**CITY OF SAINT PAUL
HERITAGE PRESERVATION COMMISSION STAFF REPORT**

FILE NAME: 531 Dayton Avenue

CLASSIFICATION: Pre-Application Review

DATE OF REPORT: March 2, 2017

SHEET TITLE
UPPER LEVEL PLANS

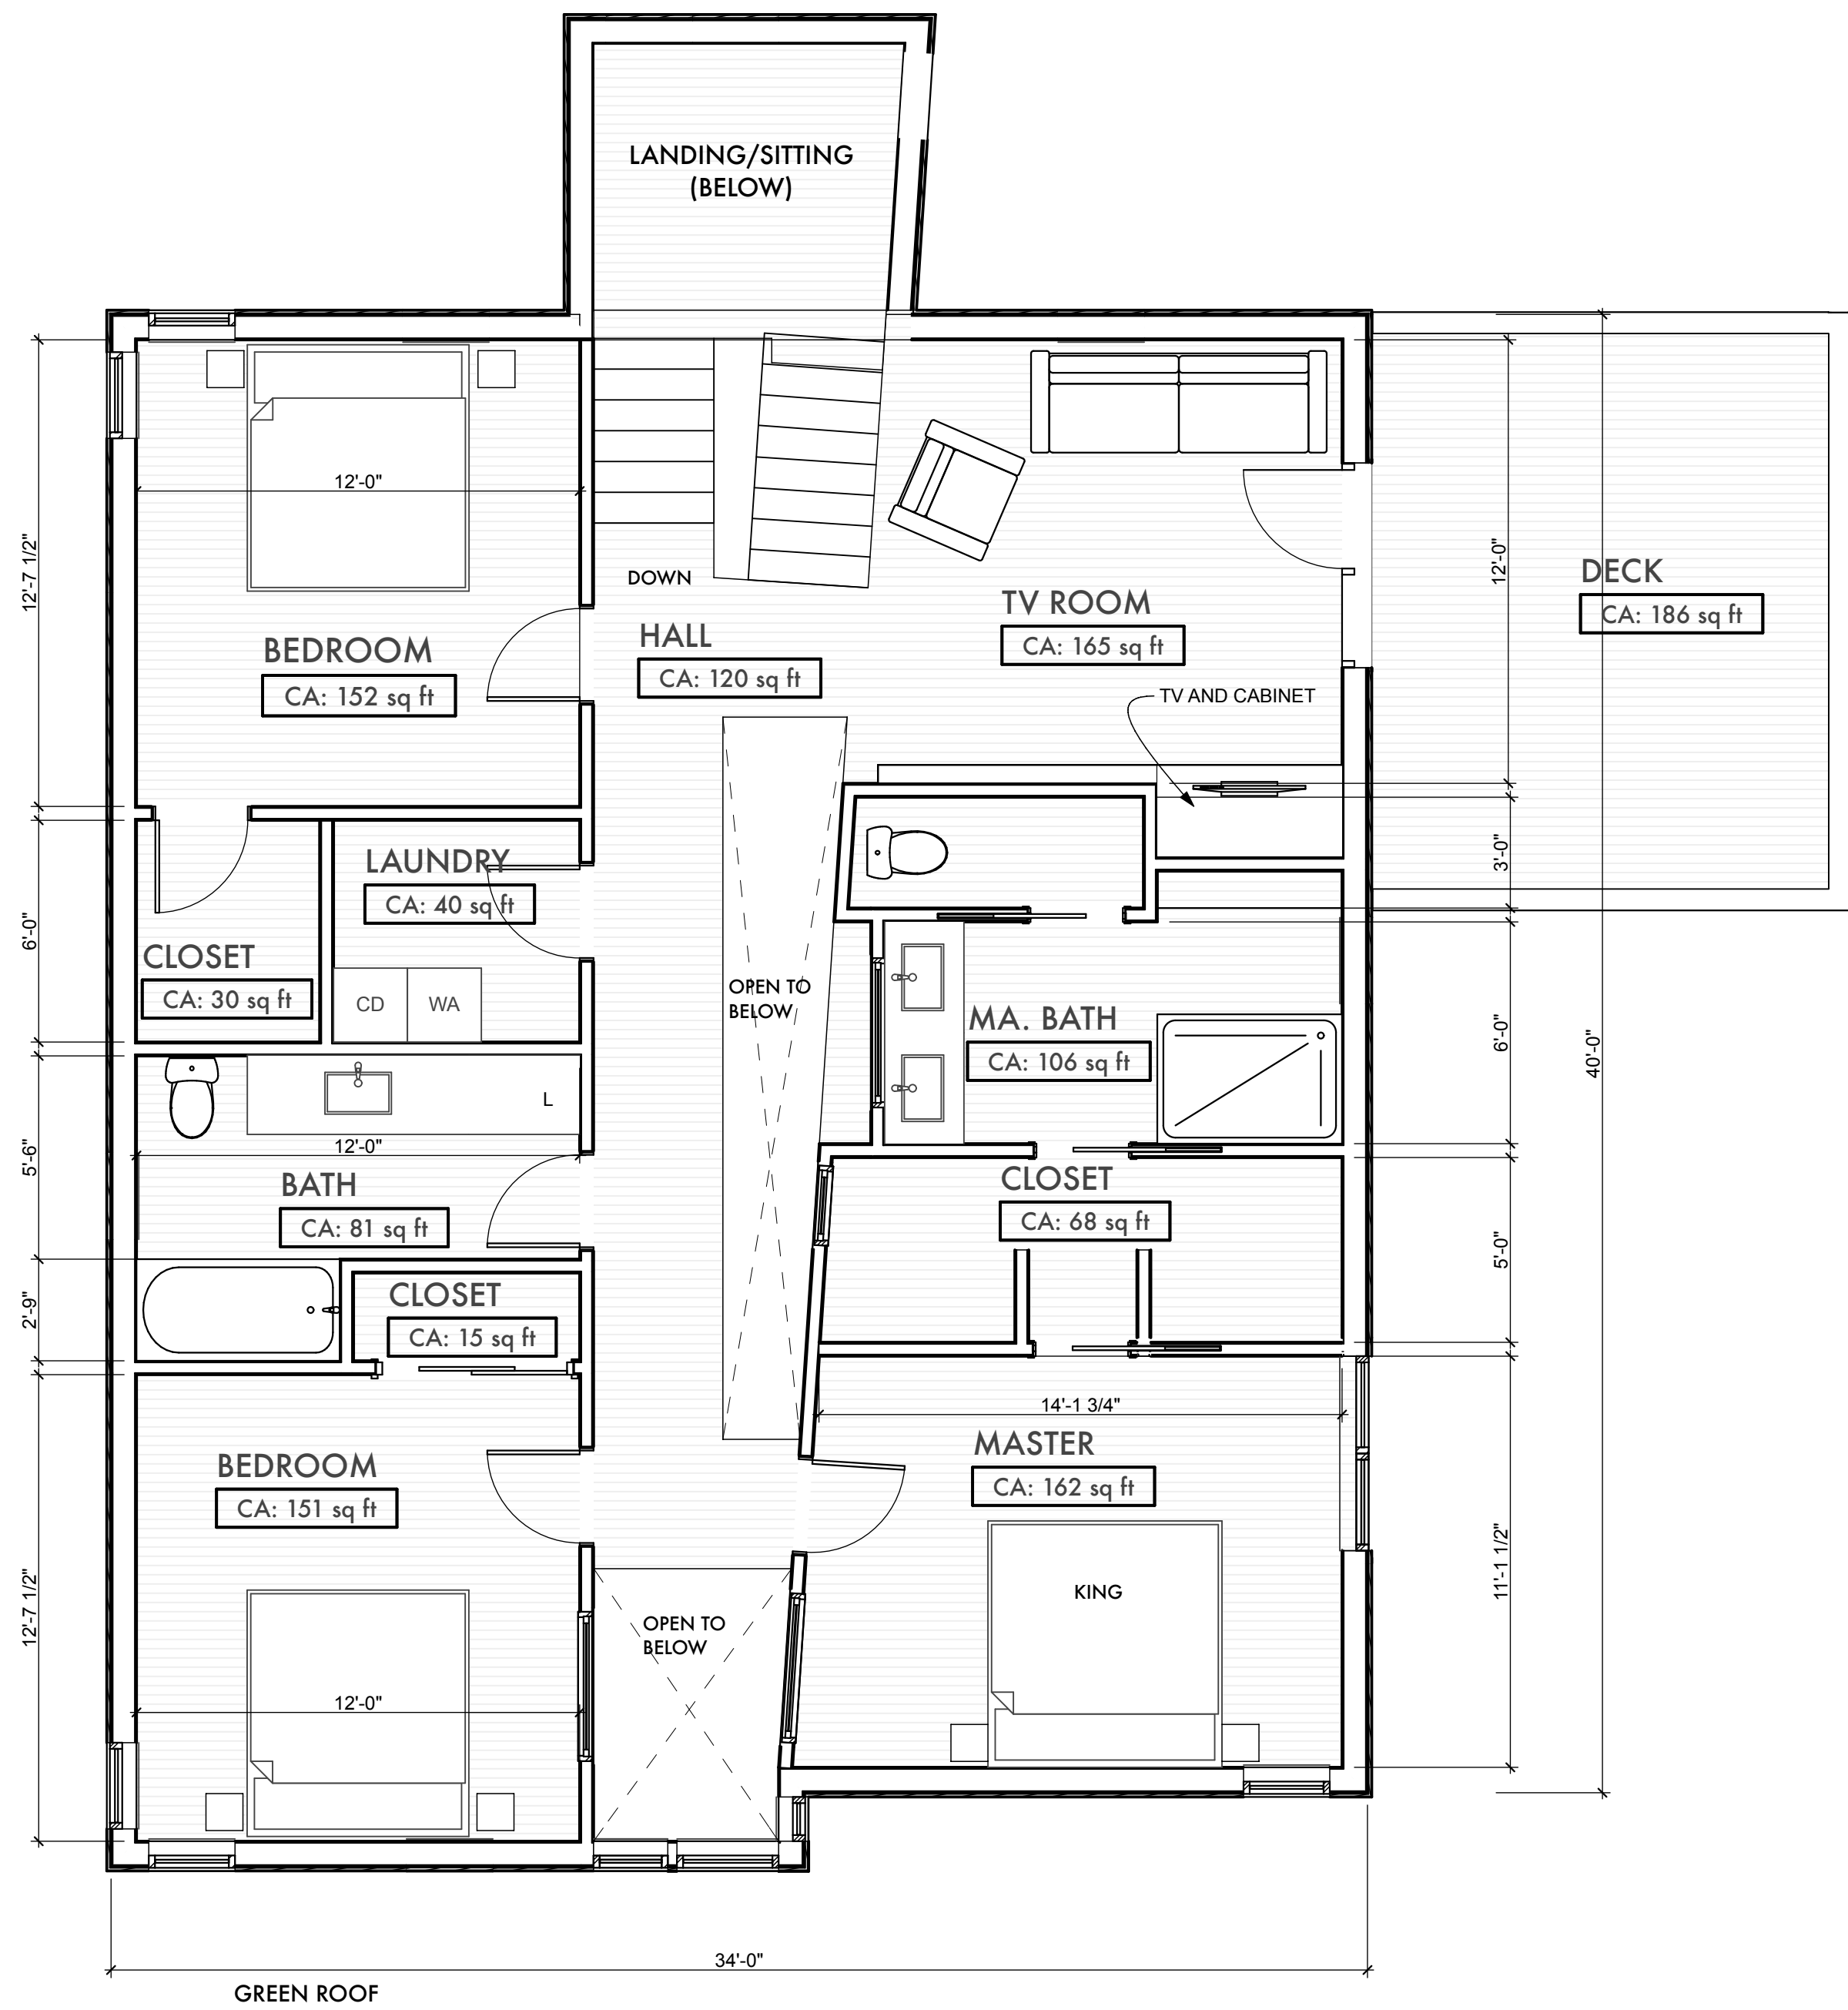
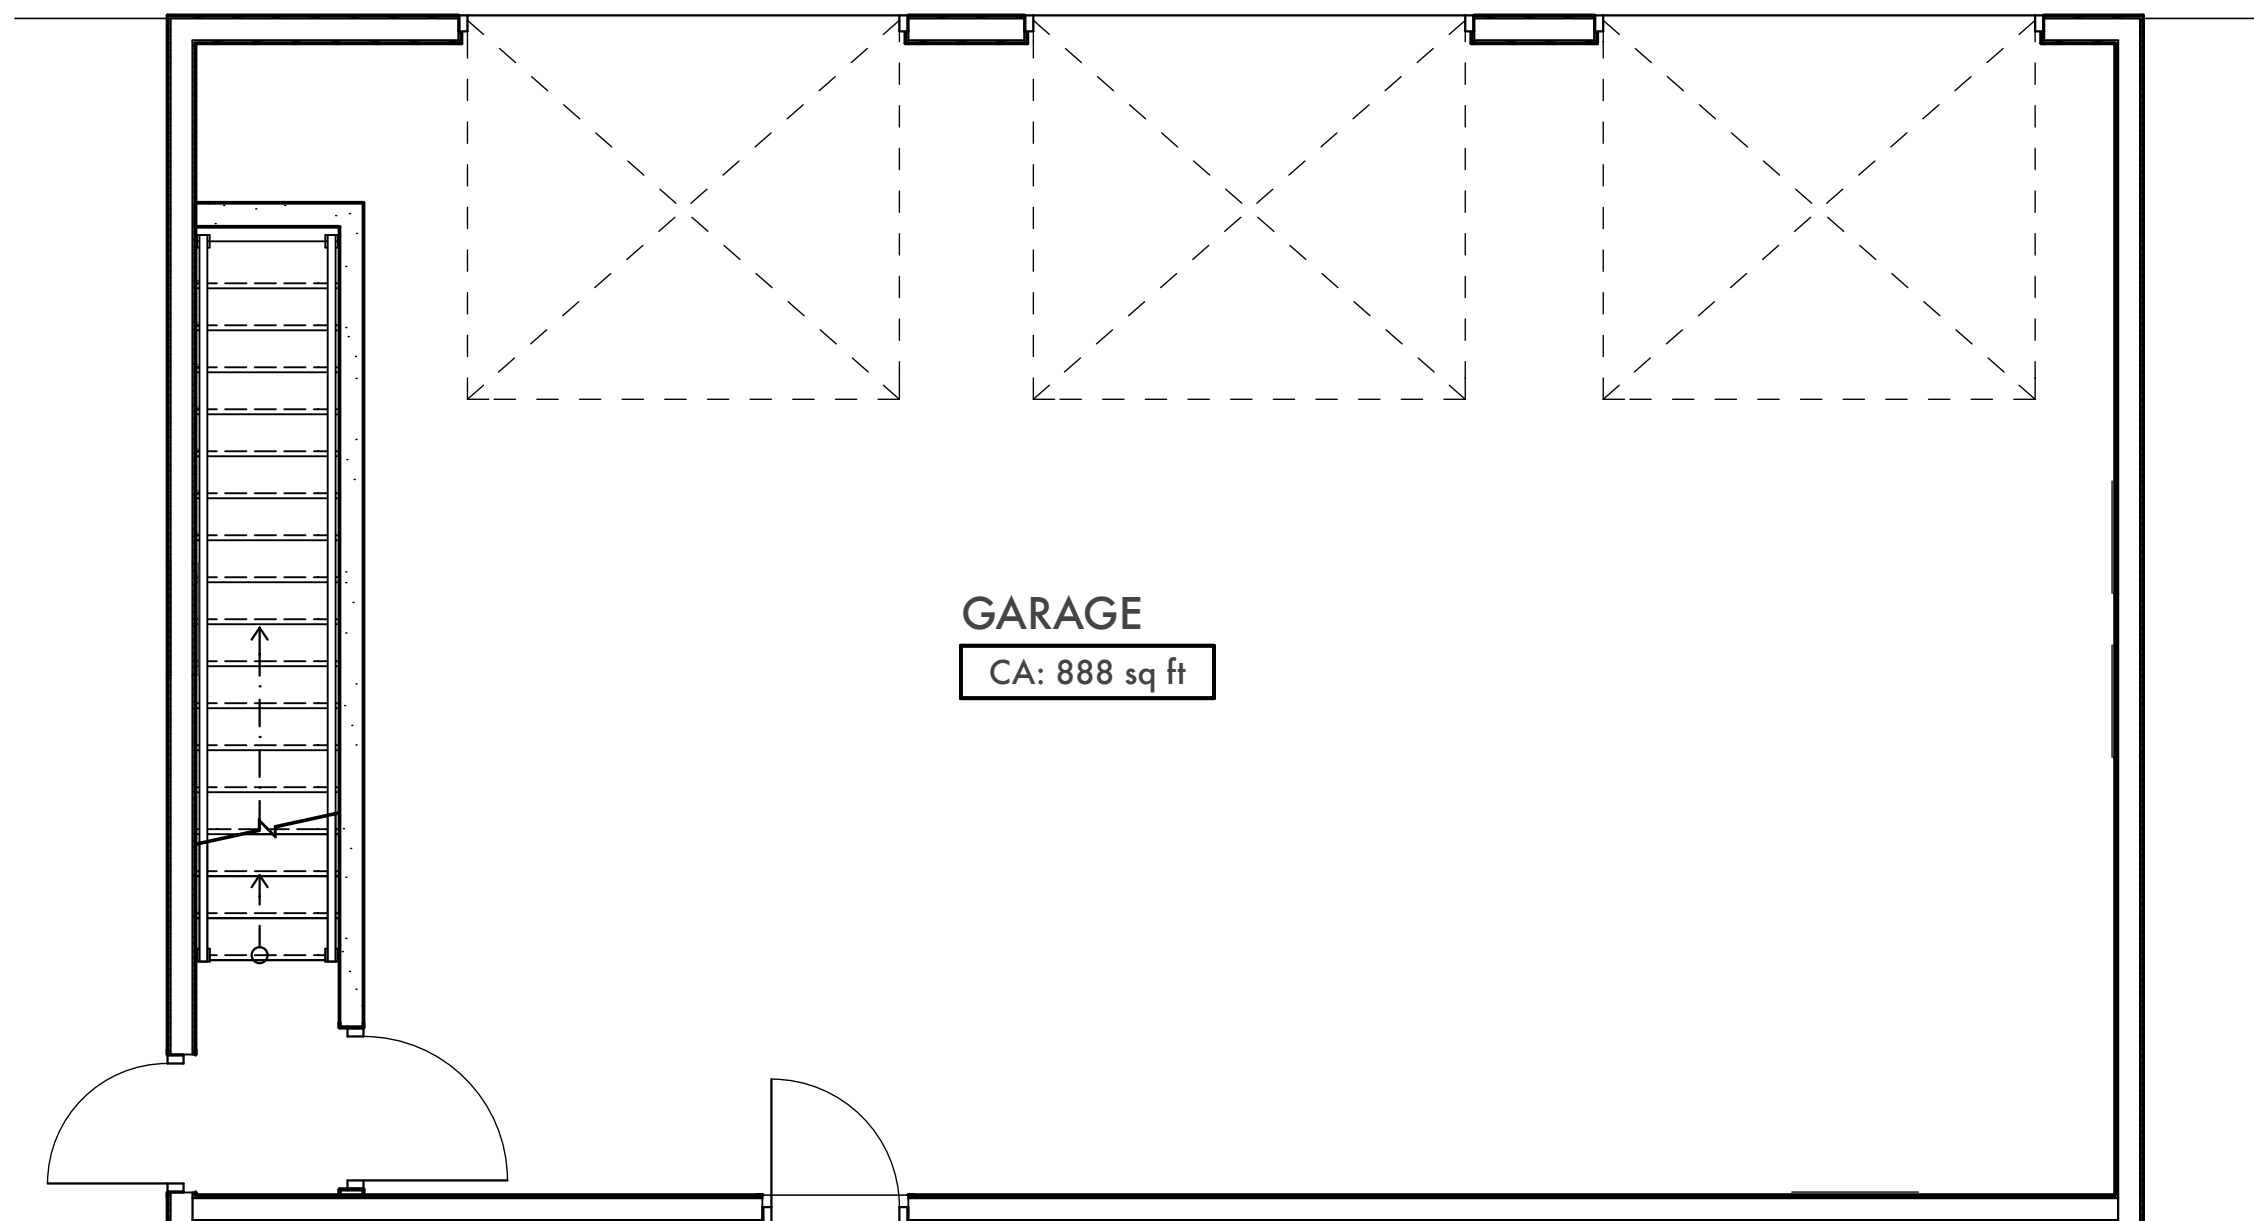
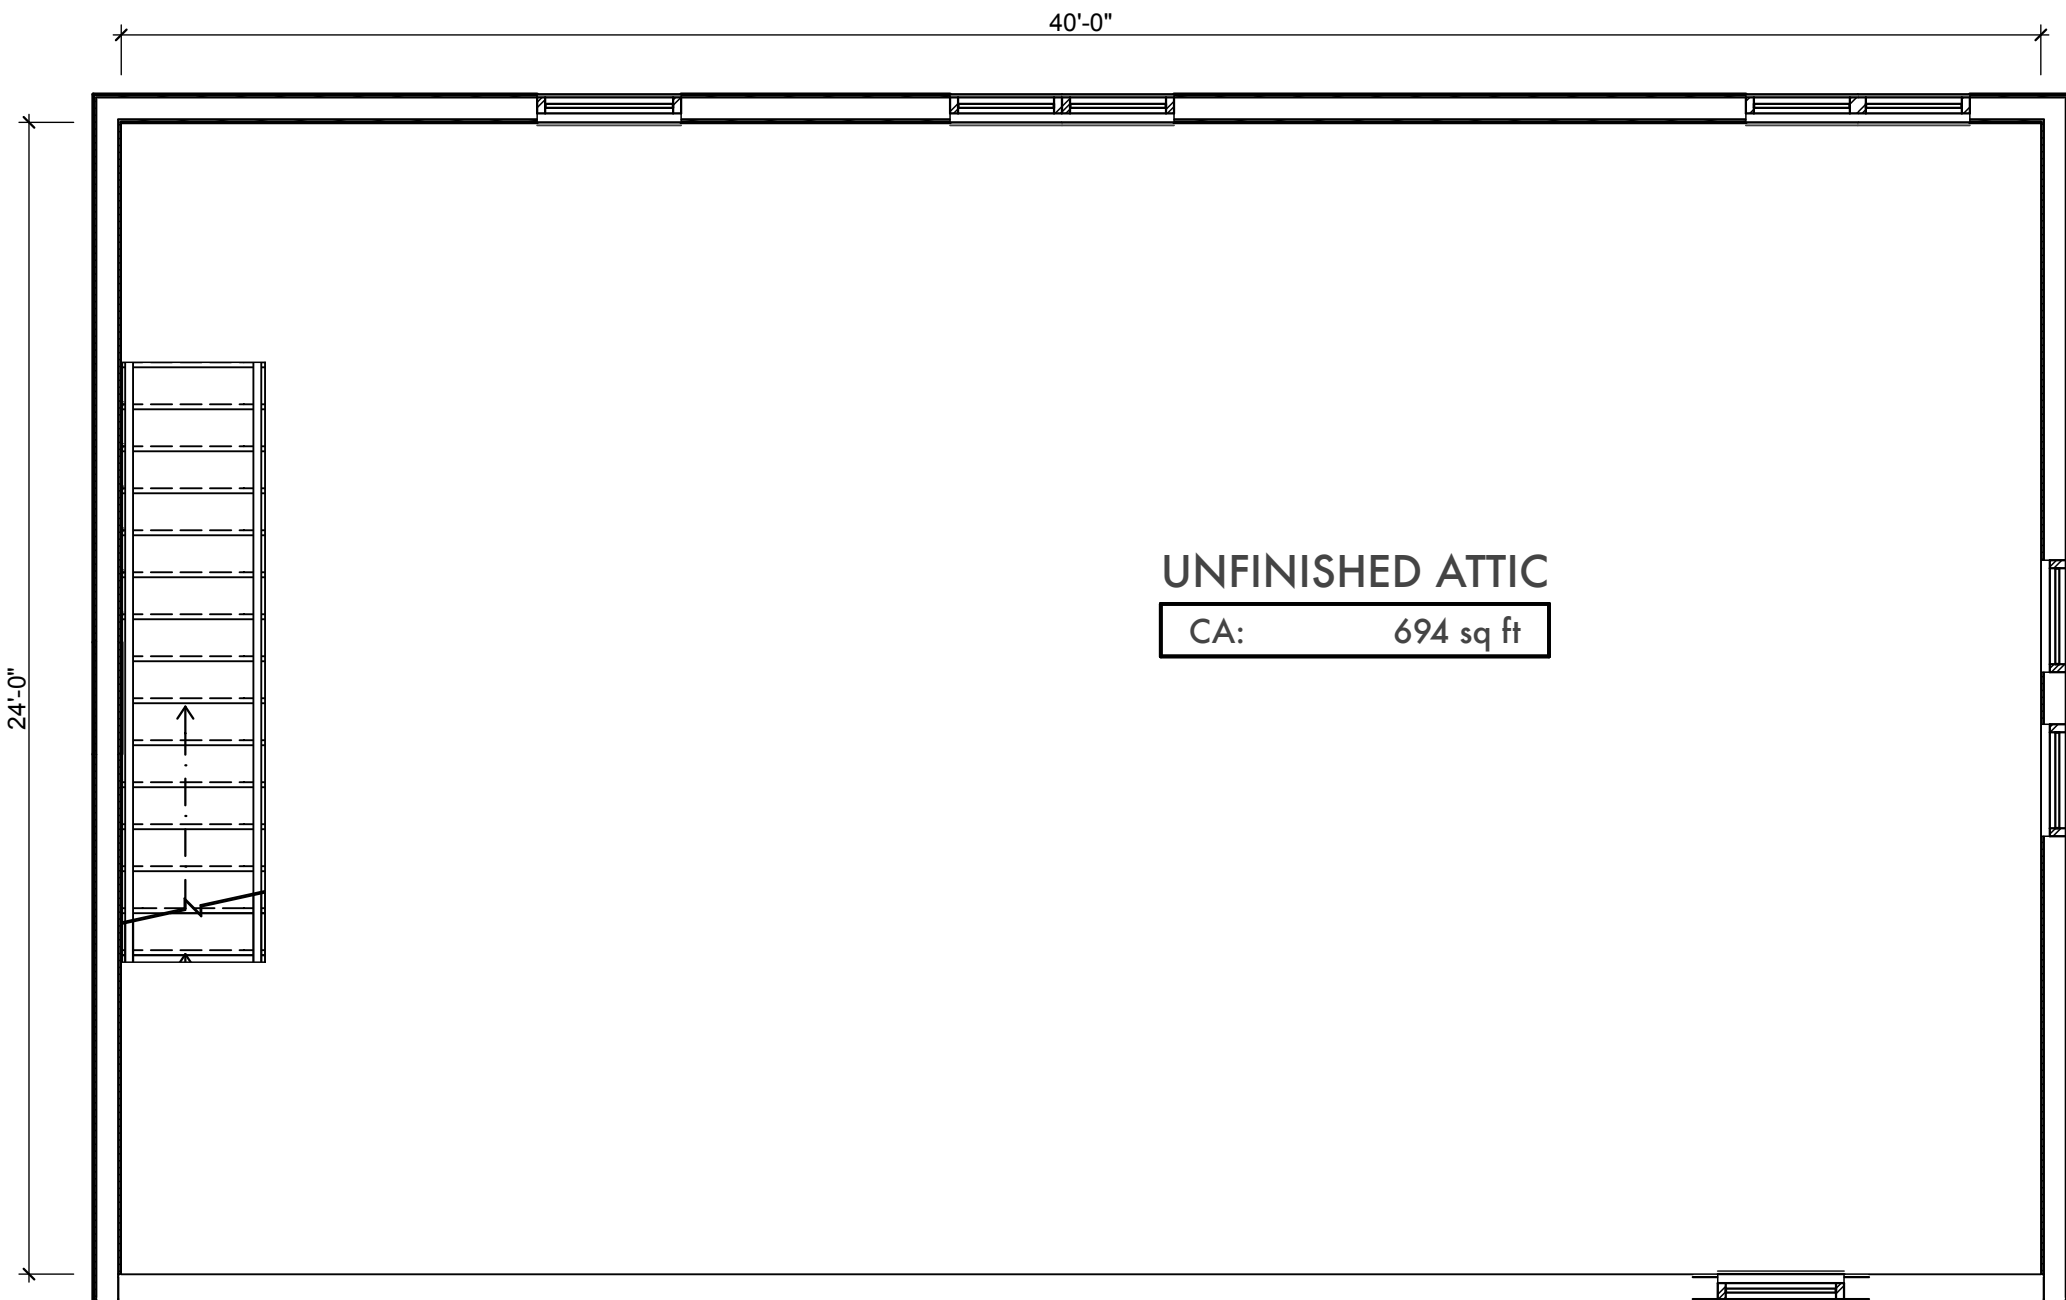
10. Building Elements: Porches and Decks. The proposed front porch *relates to the porch treatment of existing adjacent structures* in the sense that it is a one-story, open porch. However, it fails to relate *to the porch treatment of existing adjacent structures* with its small width compared to the building width, its irregular and asymmetrical roof, and its irregular support post design. Additionally, though the support posts should be visually interrupted by the horizontal line of the porch floor, the posts should carry through to grade. Also, the front porch's height is of a lower elevation than its neighbors, which generally have four to six steps from grade up to the porch. Final porch materials and details such as flooring, skirting, treads, risers, and balustrade still need to be provided and reviewed to determine full compliance with the guidelines.

The rear side porch, which is enclosed below and walk-out above, is of a rectangular form not consistent with nearby porch treatments. Though visible from the street, it is set back about 24' from the main front façade.
